# IBC - General

## **2025 GROUP B PROPOSED CHANGES TO THE I-CODES**

April 27 – May 6, 2025  
Doubletree by Hilton  
Universal Orlando - Orlando, FL

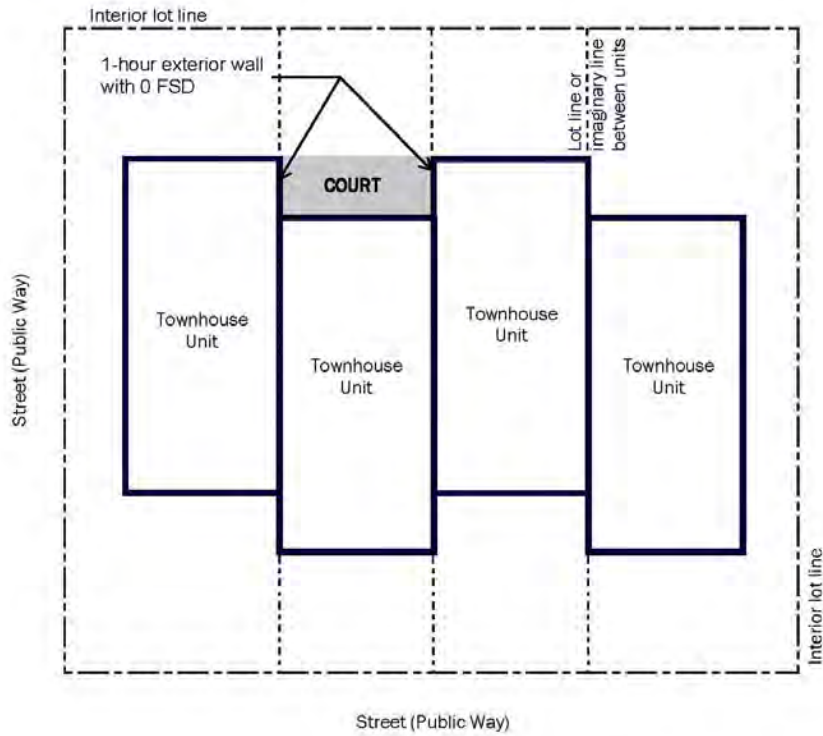
**Reason:** The current definition of townhouse unit requires that the unit have a yard or public way on two sides, and the definition of yard requires the yard to be an open space other than a court. By definition, a court is a space bounded on three or more sides by walls or buildings. Based on these definitions, townhouses that are staggered front to back create courts which are not allowed. Given that IRC Section R302.1 requires a lot line or an imaginary line between townhouse units to measure fire separation distance to, exterior walls of the units adjacent to a court will be protected based on distance to these lines, preventing fire spread from one unit to another. Therefore, there is no hazard addressed by prohibiting a court to count as an open side for a townhouse. Note that the imaginary line requirement was added in the 2024 IRC and without this there may have been a hazard in previous codes if there was no lot line and the exterior walls were not protected to prevent spread of fire from one unit to another. See figure below showing the staggered townhouse configuration with a court.

Note that if a townhouse unit has an emergency escape and rescue opening (EERO) on the court side of the unit, IRC Section R319.1 requires the court (or yard) to open to a public way, which will typically prohibit an enclosed court (i.e., all sides having a wall or building). However, if a condition exists where there are no EERO openings into the court, and exterior walls are protected based on lot lines or imaginary lines, an enclosed court would be allowed just as an enclosed yard is currently allowed.

This proposal revises the definition of townhouse unit to include a court as one of the required open sides. As described above, this condition presents no hazard due to new requirements for lot lines or imaginary lines between units.

**Wind Debris Zones for Risk Category II Buildings Based on IBC 2018**

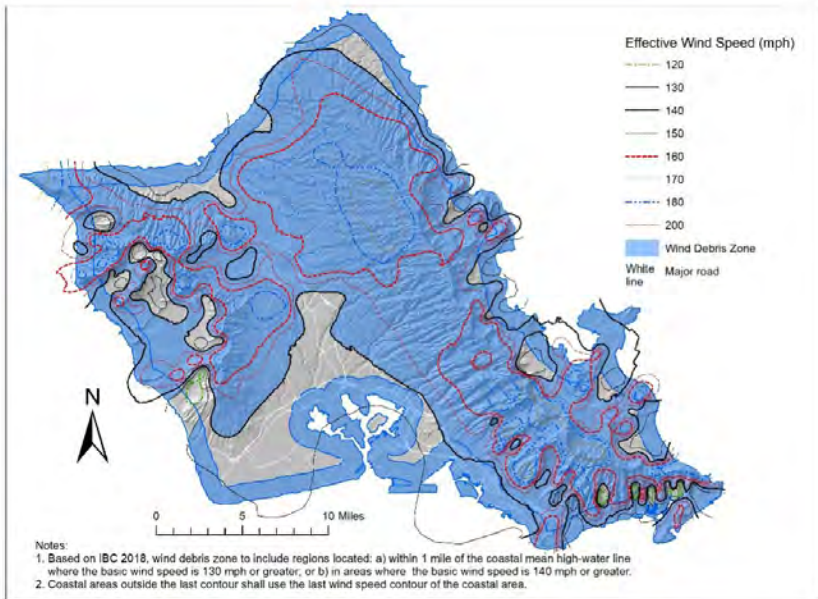
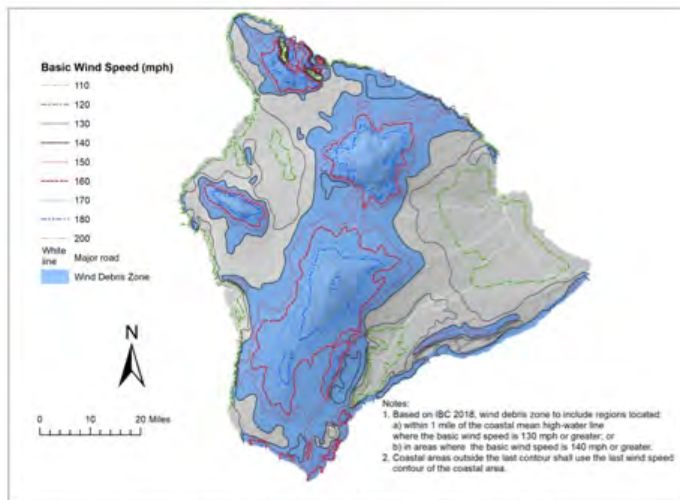
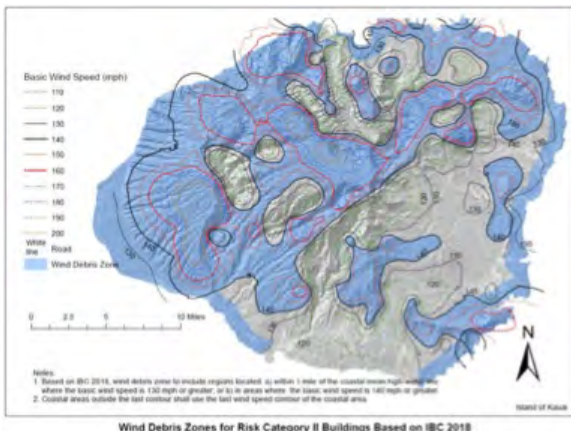
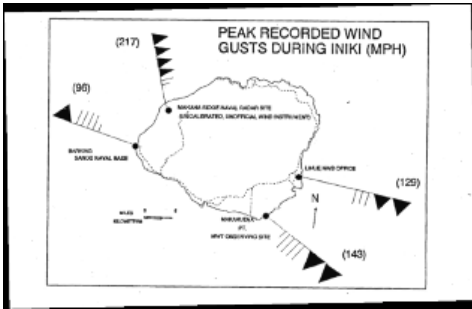
To avoid contradictions and to re-establish consistency with the simple and clear definition for Hawaii that has existed in ASTM E1996, and as proposed in what will be the 2028 edition of ASCE 7, this ICC proposal follows by adding a third category that makes it clear the entire state of Hawaii is within a wind-borne debris region. This also brings consistency with the windborne debris region definition in the IRC that does list Hawaii, although a corresponding code change to that definition has also been submitted to make the language completely identical.

Additional information with pictures that illustrate the problem follows.

The above illustrates Hawaii windborne debris regions for RC II when applying the criteria of ASCE 7-16/ASCE 7-22/IBC 2018, 2021, and 2024.

The above illustrates the problematic Kauai windborne debris regions for RC II per ASCE 7-16/ASCE 7-22/IBC 2018, 2021, and 2024.

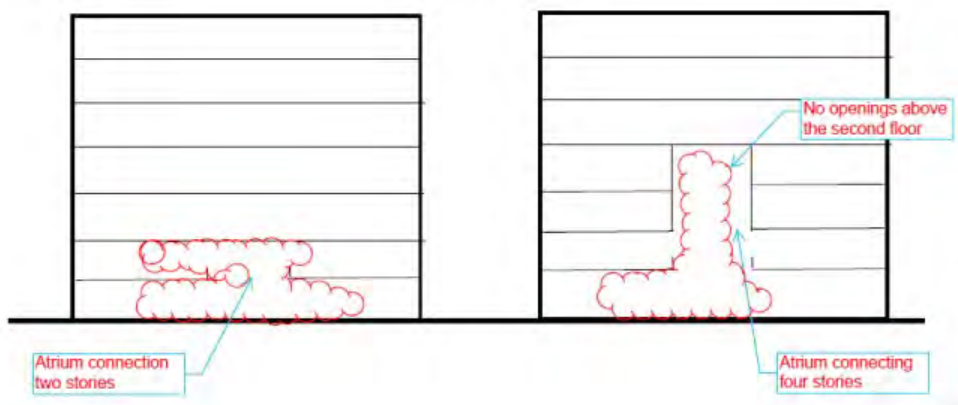
**Reason:** Starting with the 2015 IBC, components of the means of egress system have been allowed to be in an atrium: 1019.3 Exception 5, 1023.2 Exception 2 (E139-12). It is important to note that the reason statement for change proposal E139-12 assumed that an atrium would be “protected by various active systems including ... smoke control features.”

Later, the 2021 IBC introduced a revised Section 404.5 (G32-18) providing another exception allowing no smoke control for atriums taller than two stories.

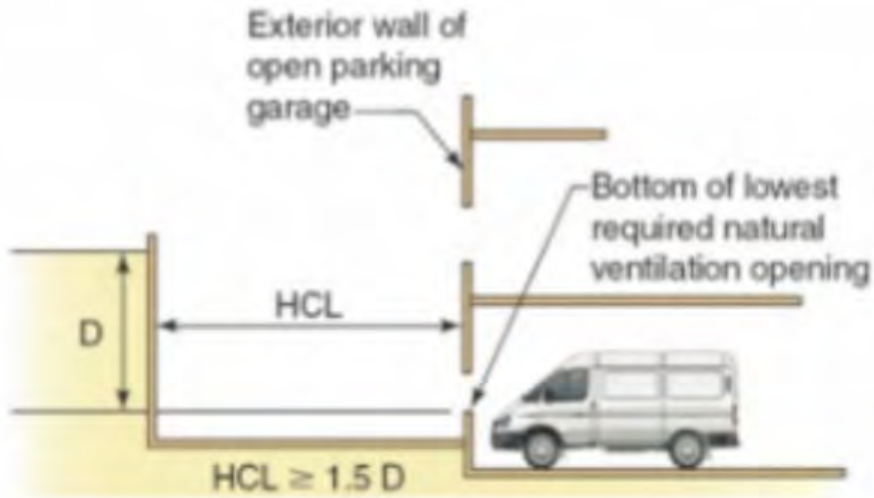
**406.5.2.2 Opening above grade.** When ventilation wells are used to satisfy natural ventilation requirements for open parking garages, the width of the ventilation well opening to sky shall be one and one-half times the height of the adjacent structure to the bottom of the lowest required opening. The minimum required width of the ventilation well shall be maintained for not less than the length of the required openings.

**Exception:** The ventilation well opening width is not restricted if any of the following are met or provided:

1. Supplemental mechanical ventilation meeting the requirements of Section 406.6.2 is provided for the open parking garage.
2. Where approved by the building official, an engineering analysis proving equivalent natural ventilation requirements are met.

**FIGURE 503.1 LOCATION OF ELEVATED PV SUPPORT STRUCTURES ON OPEN PARKING STRUCTURES**

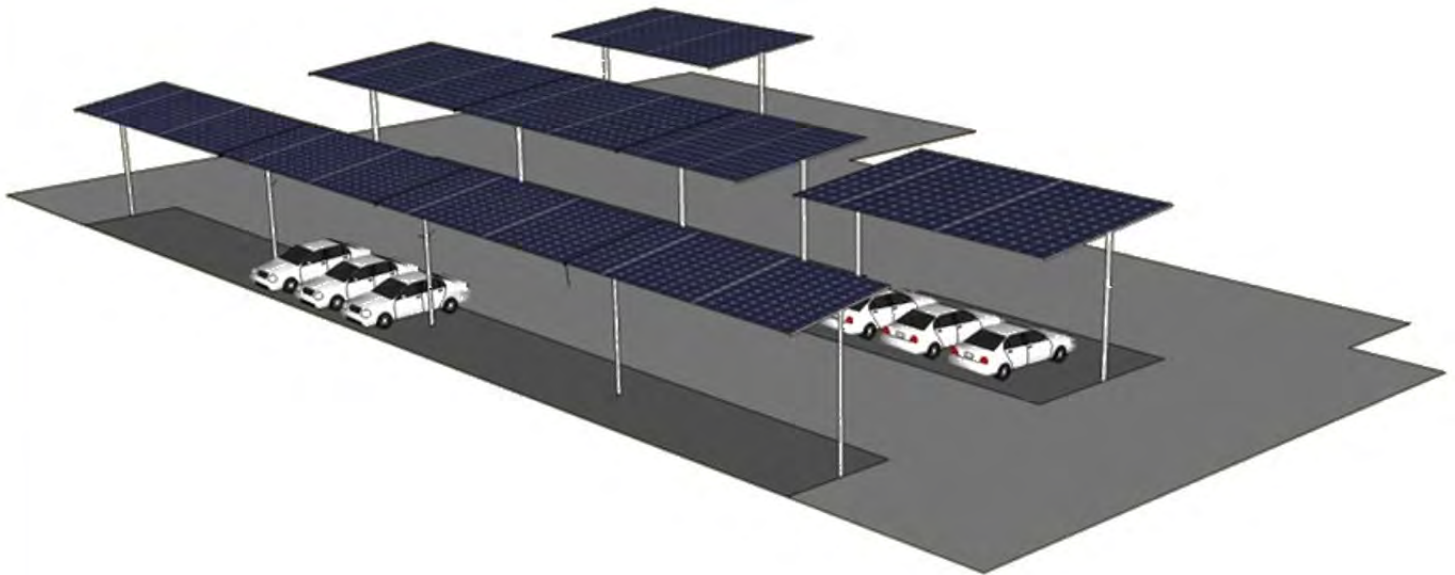
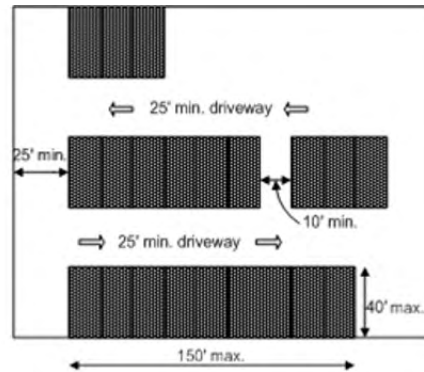
- 1.2.1. 10 feet (3050 mm) above the allowable building height.
    - 1.2.2. 10 feet (3050 mm) above the roof of the building immediately below.
2. Other than structural requirements, elevated photovoltaic (PV) support structures installed on the roof of an open parking structure or the roof of an enclosed parking garage shall not constitute an additional story or additional floor area and shall be permitted to exceed the height limit of a building where all the following conditions are met (see Figure 503.1):

- 2.4. Elevated PV support structures are used only for parking purposes with no storage.
  - 2.5. Elevated PV support structures are completely open on all sides, other than necessary structural supports, with no interior partitions.

**Reason:** The primary objective of this proposal is to provide exceptions to clarify that elevated PV support structures can be installed on top of a multi-story parking garage under certain conditions without impacting restrictions on number of stories, height or area. Likewise, under certain conditions, rooftop-mounted PV systems do not cause a building to be noncompliant with these provisions. The exceptions in this proposal are similar to exceptions that have existed in the California Building Code for several cycles, with support of the fire service and without any compromises in safety to the building or fire fighters. These exceptions will not impact the ability to fight fires on top of buildings.

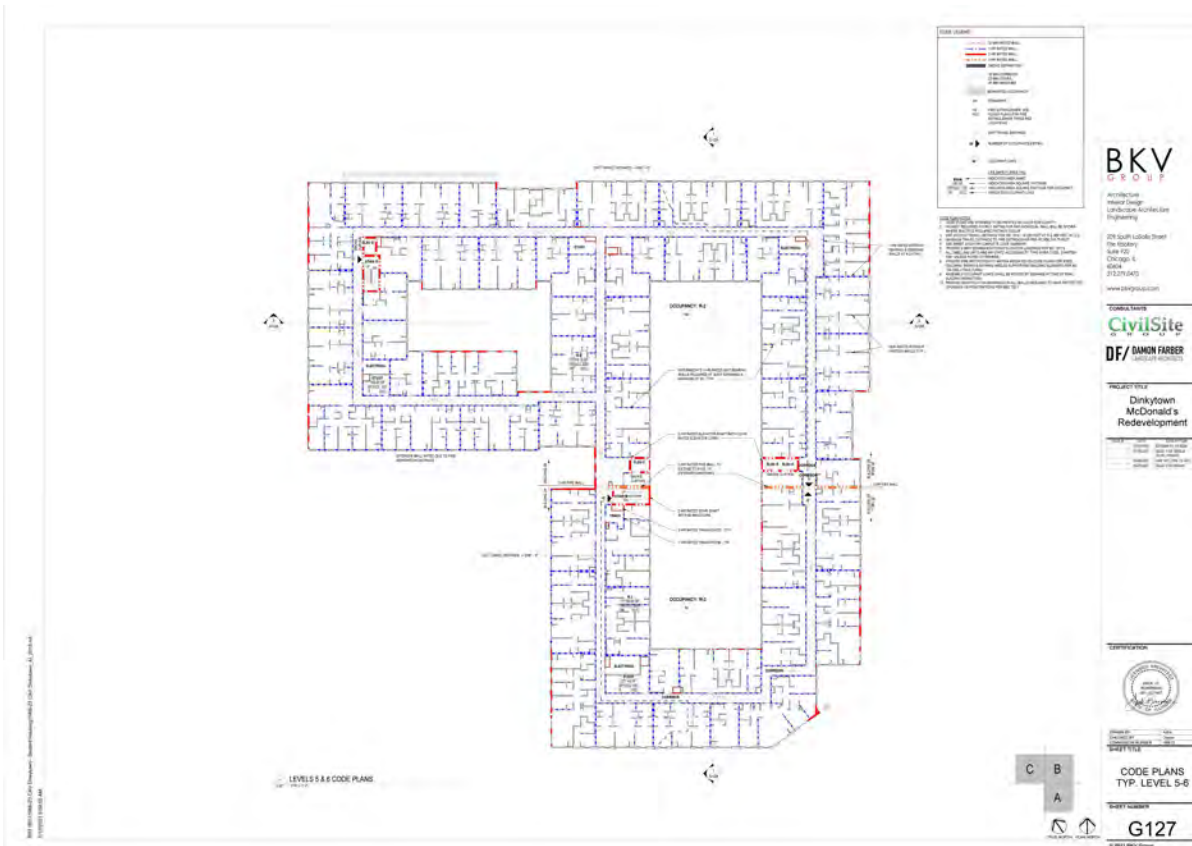
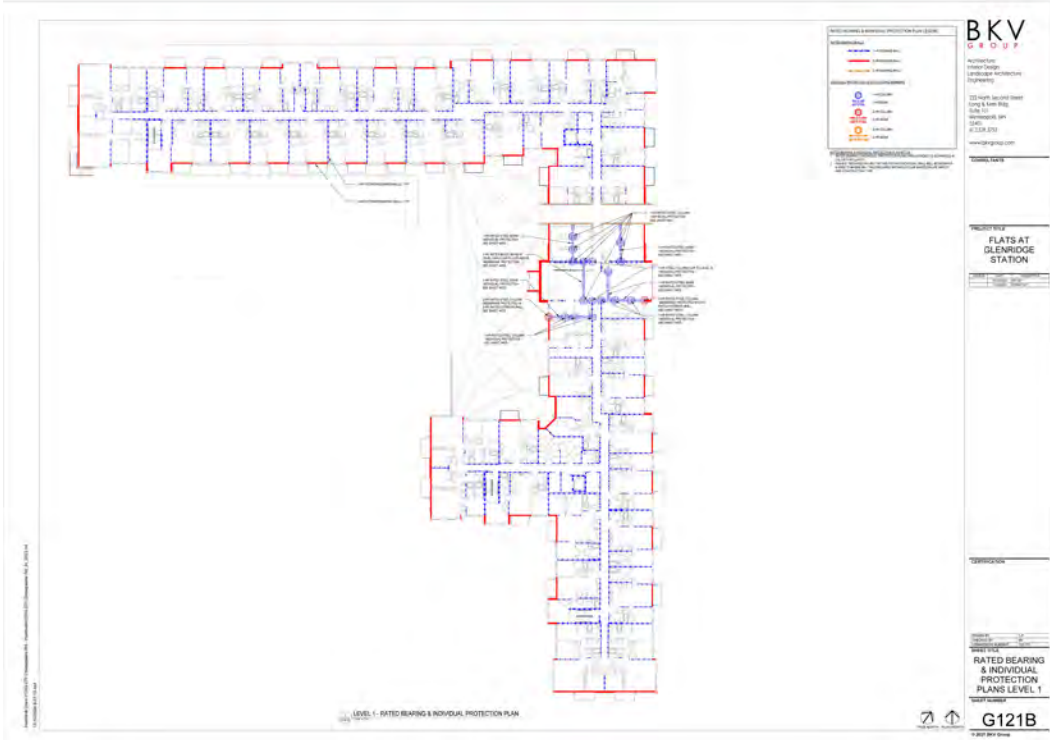
Type III construction is used extensively in the construction of R-2 dwelling units. The current construction practice is to run the floor and roof framing members parallel to the long dimension of the building. Limiting the amount of exterior bearing wall to the greatest extent possible. In a simple rectangular building this is not a significant issue. However most of these structures have numerous recesses in the exterior walls, due either to meeting zoning requirements for articulated facades or to provide for private decks and balconies. These articulations result in numerous short sections of exterior bearing walls. Many as short as 3-5 feet. The code requires that exterior bearing walls have a 2-hr fire resistive rating, designers, contractors and code officials spend an enormous amount of time and energy tracking all of these isolated wall assemblies through the building. This can get even more difficult when on upper levels the building steps back to create a smaller footprint on the upper levels. Again often in response to zoning requirements. Now not only the exterior bearing wall on this upper level is required to be 2-hr rated but all the supporting construction down through the interior of the building must also be 2-hr rated. Often the upper floor will have a different framing arrangement than the lower floor with a larger footprint. So the exterior bearing wall on floor 4 may in fact be above but back from an exterior non bearing wall on the floor 3.

Attached example 1 shows a typical large scale type III apartment building. The exterior 2-hr rated walls are shown in red. Note that the entire north wall is non-rated construction. Note that in the middle of the north wall there are two 4 foot long walls perpendicular to the lot line that are 2-hr rated. The east and west walls have 2-hr rated assemblies for approx. 46% of the exterior wall and those rated assemblies are located at the extreme ends of the walls. The building walls facing the courtyard are also exterior walls and therefore include some 2-hr ratings.

Attached example 2 shows another typical type III apartment building. This one has balconies. Because of the definition of bearing walls these balconies create a series of exterior walls that qualify as bearing walls. The entire exterior wall design is a running pattern of non rated wall next to 2-hr rated wall next to non-rated wall next to 2-hr rated wall and on and on.

The point of these two examples is to show that, while it is possible to meet the letter of the code, it does not meet the original intent of the code sections. This alternating protected / non-protected pattern does not provide any realized protection of the structure, occupants, or first responders.

**FIGURE 3004.2.3 ESCALATOR GUARD**

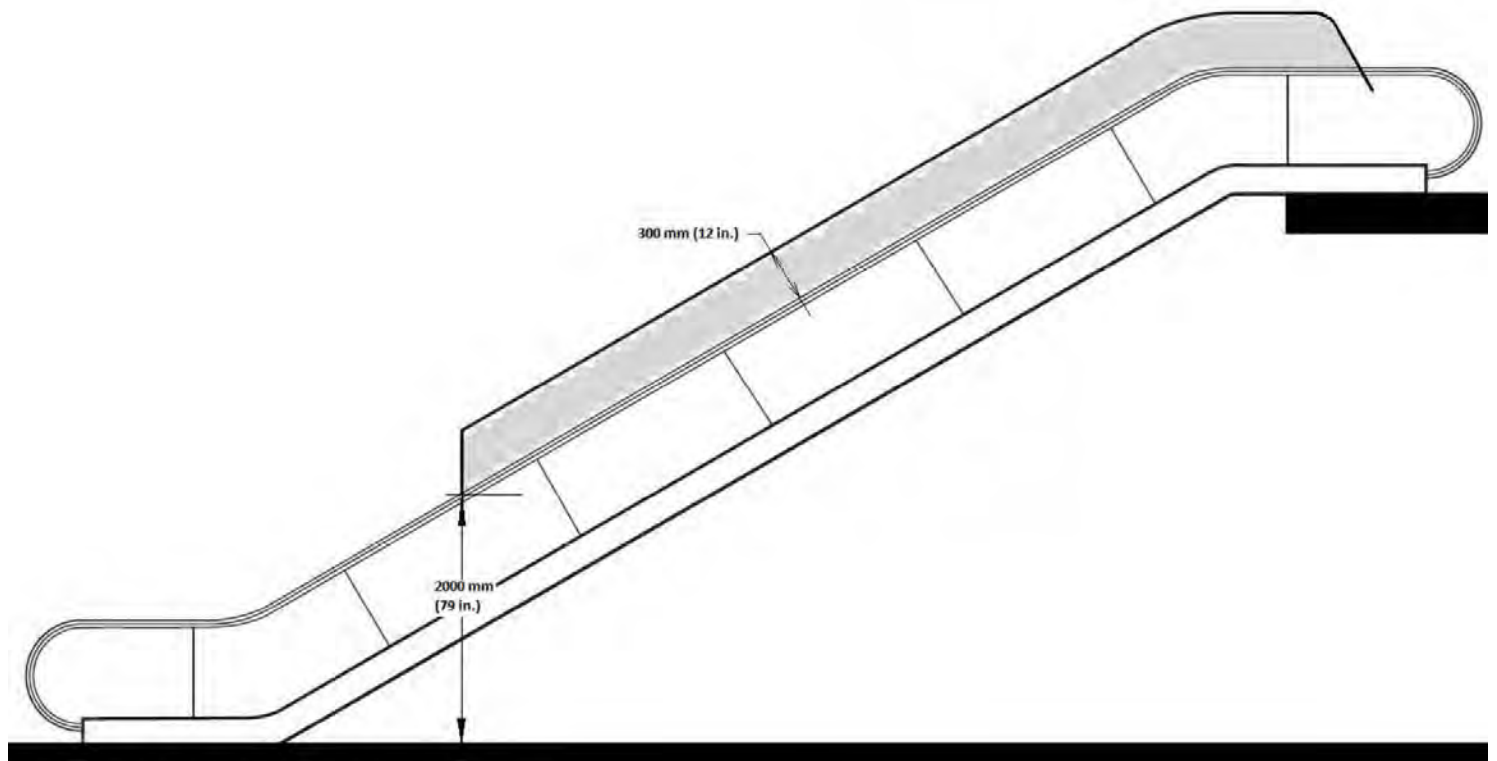
**3004.2.3 Balustrades required.** Where escalators or moving walks are installed with one or both sides open and the escalator step or moving walk treadway is more than 30 inches above the adjacent floor, the balustrades shall be not less than 42 inches (1067 mm) in height or the side or sides shall be guarded to comply with ASME 17.1/CSA B44, Appendix ZZ. See Figure 3004.2.3.

**Reason:** Provide height requirements for balustrades or additional guarding for open-sided escalators and moving walks to align with guard height requirements in section 1015.3. This addresses a potential fall hazard for installations without full enclosures that are open
